Access Compliance Report

Public Rights-of-Way

(Curb Ramps)

Intersection ID: 21991	Main Street: WINGET_RD	Cross Street: WITHERS_MILL_DR	Location: NW
ADA ID: 9F48E7B473EA	Ramp Type: PerpDiag	Initial Pass/Fail: Fail	Overall Compliance: No
Severity Score: 25			
Codes/Mitigation Info/Possible Solution		Field Measurements/Component Compliance

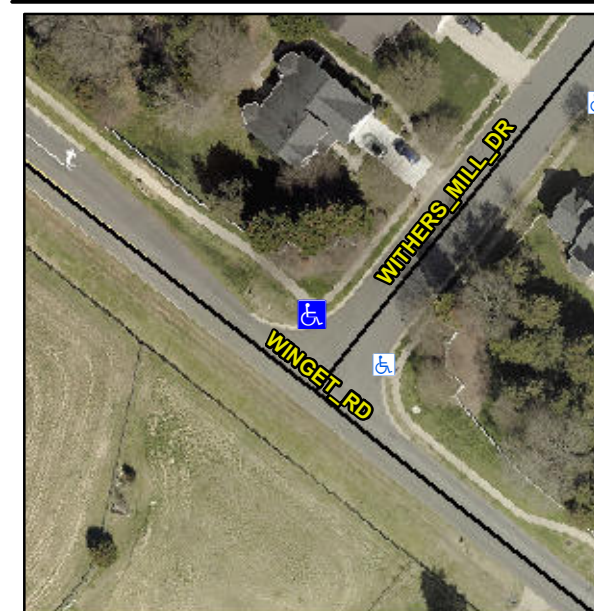
Not Found, R304.5.3

Compliance	Description	Data	Compliance	Description	Data
N/A	Ramp Length (in)	50.0	Yes	Ramp Slope (%)	7.6
Yes	Ramp Width (in)	48.0	No	Ramp XSlope (%)	7.3
N/A	Flare Type LT	N/A	N/A	Flare Type RT	N/A
N/A	Flare Slope LT (%)	N/A	N/A	Flare Slope RT (%)	N/A
N/A	Flare Traversable LT?	N/A	N/A	Flare Traversable RT?	N/A
N/A	Landing Length (in)	N/A	N/A	DWS Provided?	N/A
N/A	Landing Width (in)	N/A	N/A	DWS Contrast?	N/A
N/A	Landing Slope (%)	N/A	N/A	DWS Length (in)	N/A
N/A	Landing X Slope (%)	N/A	N/A	DWS Full Width?	N/A
N/A	Landing Curb? (Y/N)	N/A	N/A	DWS Offset (in)	N/A
N/A	Shared Landing?	N/A			
N/A	Gutter Ponding?	N/A	N/A	Gutter Slope (%)	N/A
N/A	Gutter Lip Ht (in)	N/A	N/A	Gutter X Slope (%)	N/A
N/A	Painted X Walk1?	No	N/A	Painted X Walk2?	No
	X Walk 1 Direction	To SW		X Walk 2 Direction	To SE
N/A	X Walk 1 Width (in)	N/A	N/A	X Walk 2 Width (in)	N/A
	X Walk 1 Slope (%)	8.1		X Walk 2 Slope (%)	1.5
	X Walk 1 X Slope (%)	1.4		X Walk 2 X Slope (%)	7.2

Remove & Replace Curb Ramp With Two New Directional Ramps or Equivalent.
